TO:	Plan Holders
PROJECT NAME:	Nutmeg Lane Pump Station Upgrade, Glastonbury, CT
SUBJECT:	Addendum No. 1
FROM:	Dennis A. Dievert, Jr., P.E.
PROJECT NO.:	12145C

ADDENDUM NO. 1

NUTMEG LANE PUMP STATION UPGRADE

APRIL 18, 2012

TOWN OF GLASTONBURY, CONNECTICUT
BOARD OF SEWER COMMISSIONERS
HUBBARD BROOK AREA SEWERS
NUTMEG TRUNK
STA. 7+00 TO STA. 13+54
NUTMEG FORCE MAIN
STA. 0+00 TO STA. 4+85

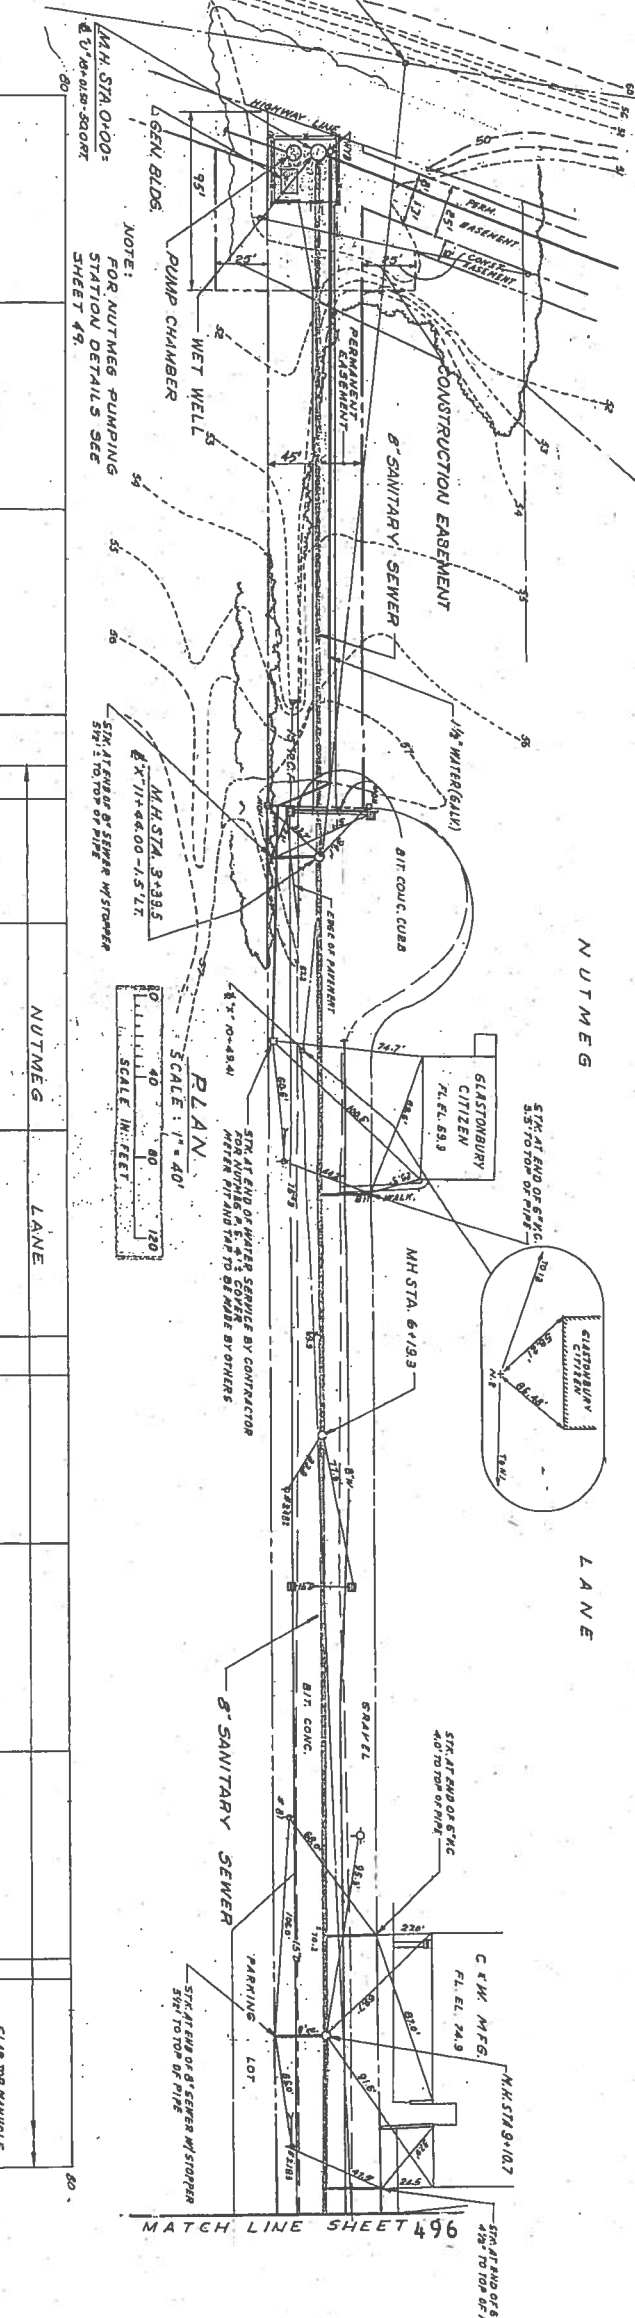
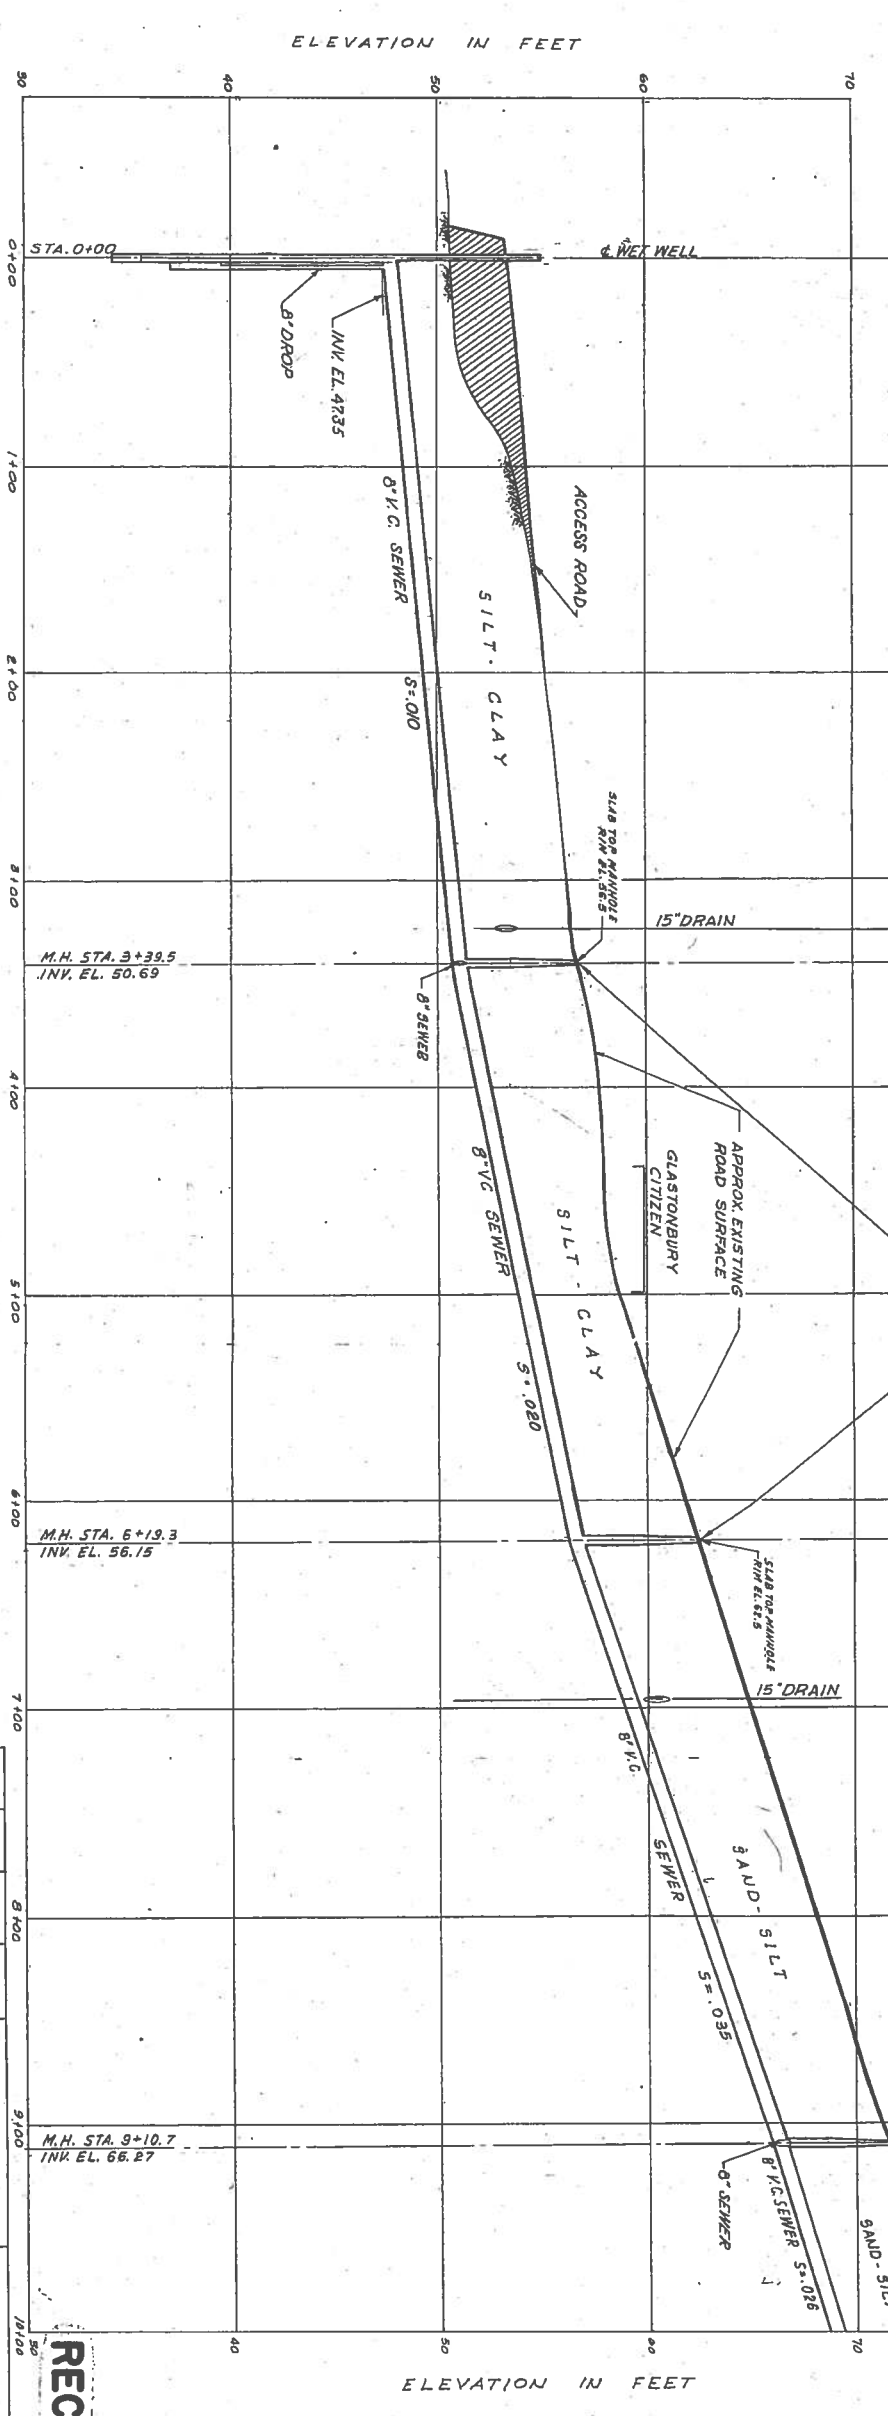
12. **Q:** *How long is the existing force main?*
A: The existing force main is approximately 500-feet long. Sewer As-Builts from 1966, showing the locations of the upstream manholes and force main route, are included on Page 15 of 17 to Page 17 of 17 in this Addendum. Please be advised that these

14. **Q:** *Do you have an exact location on the northernmost sewer manhole and how far from the wetwell it is?*
- A: Sewer As-Builts from 1966, showing the locations of the upstream manholes and force main route, are included on Page 15 of 17 to Page 17 of 17 in this Addendum. Please be advised that these drawings do not accurately represent current site features and shall be used for information only when establishing the contractor's bid.

TOWN OF GLASTONBURY, CONNECTICUT
BOARD OF SEWER COMMISSIONERS
HUBBARD BROOK AREA SEWERS
BENTON LANE LATERAL
STA. 0+00 TO STA. 11+00

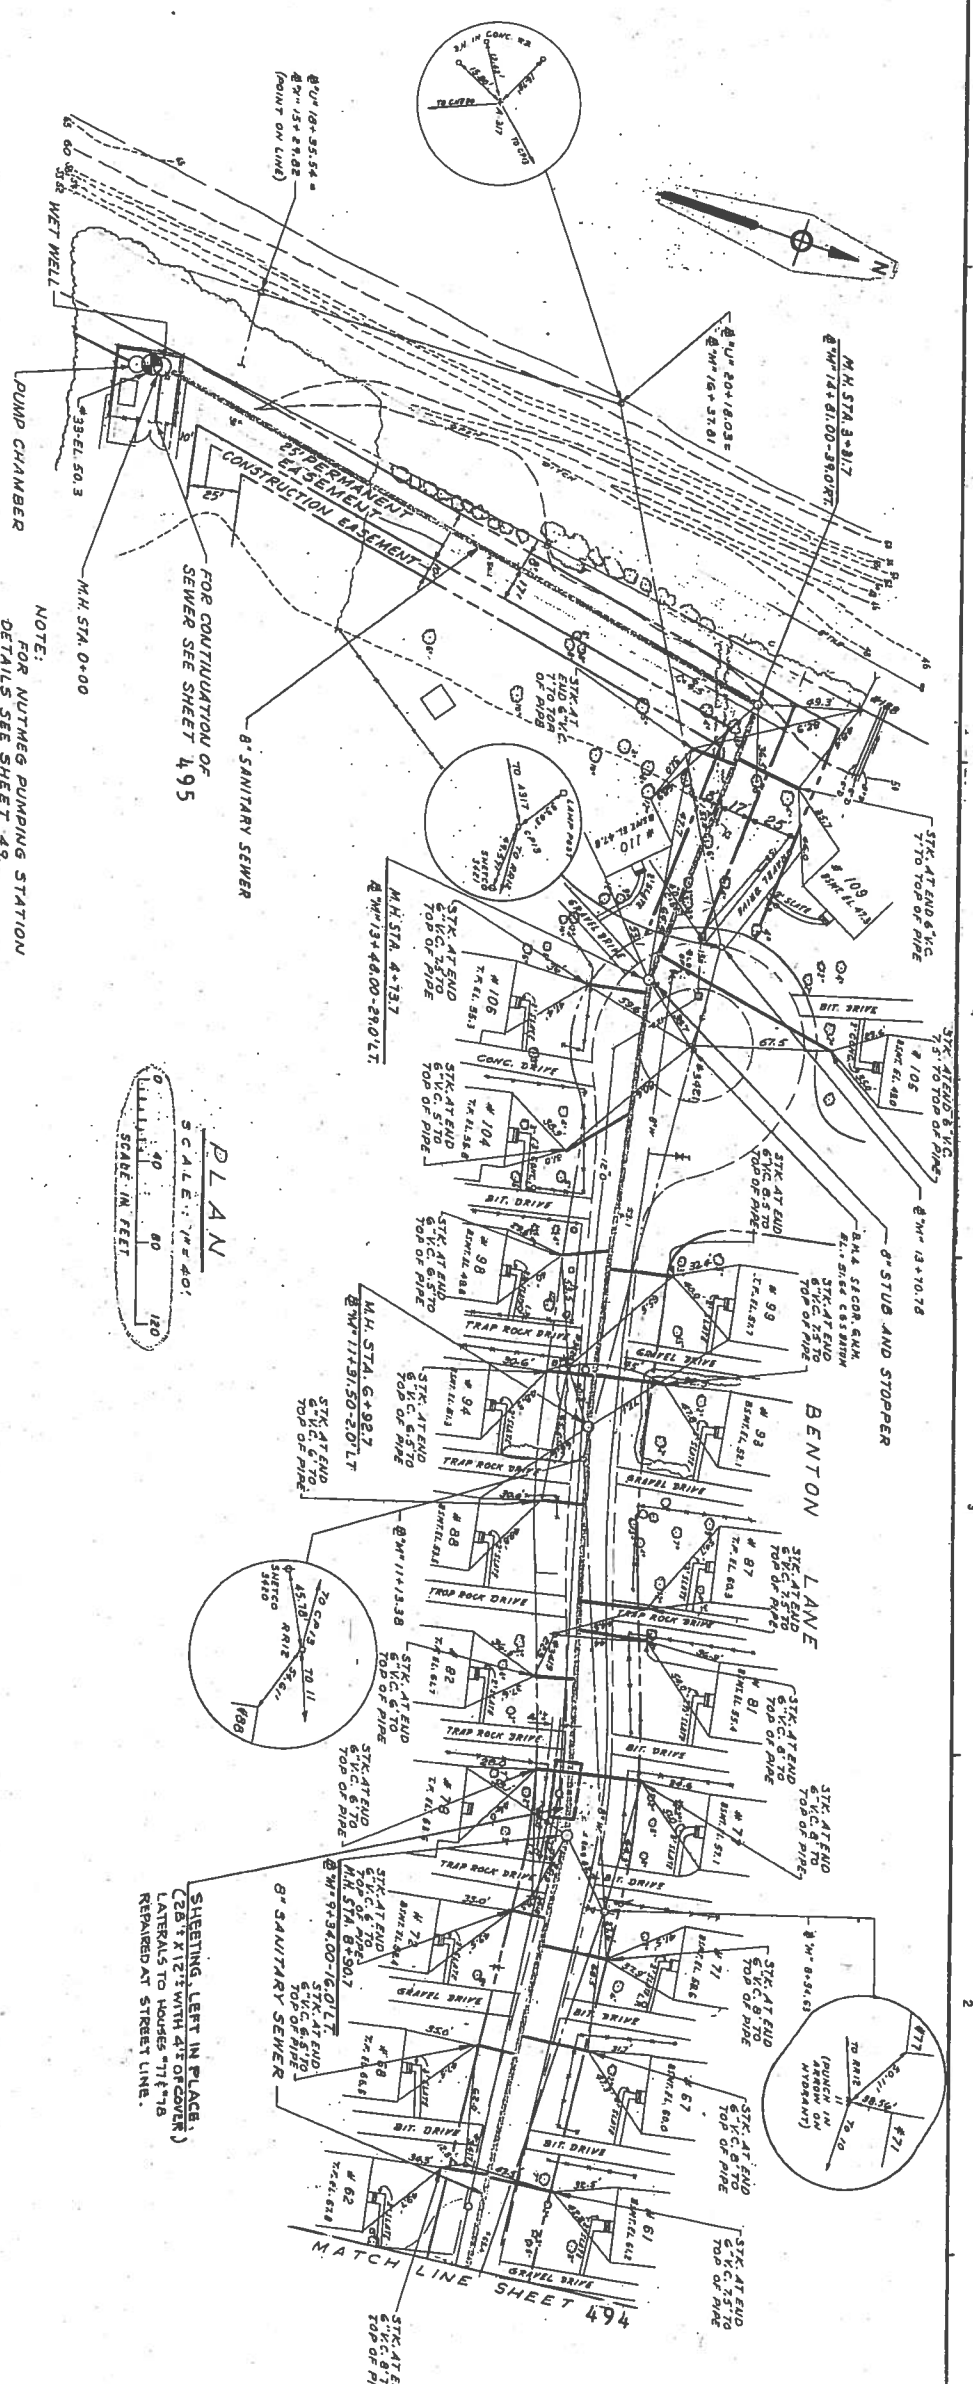
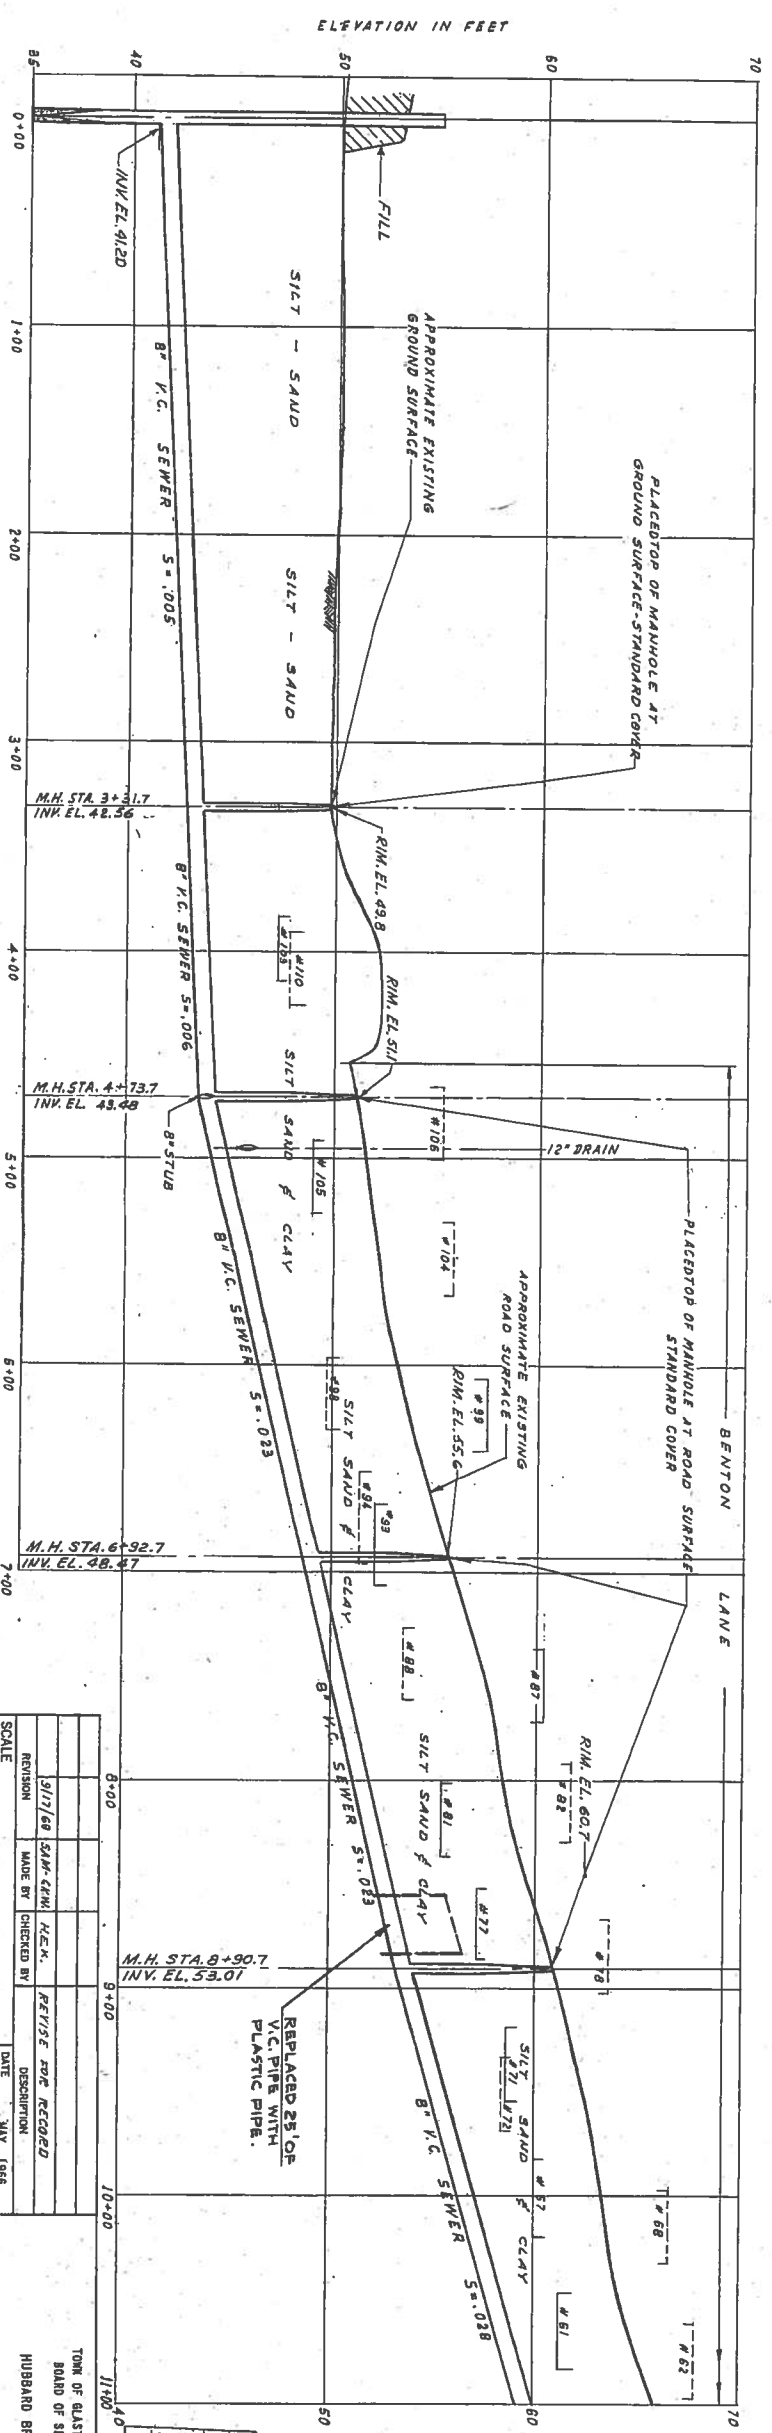
9. **Q:** *Are there any existing borings on the site?*
A: There are no existing boring available but there is some information of the soils on the profile drawings of the incoming sewers included in this addendum.
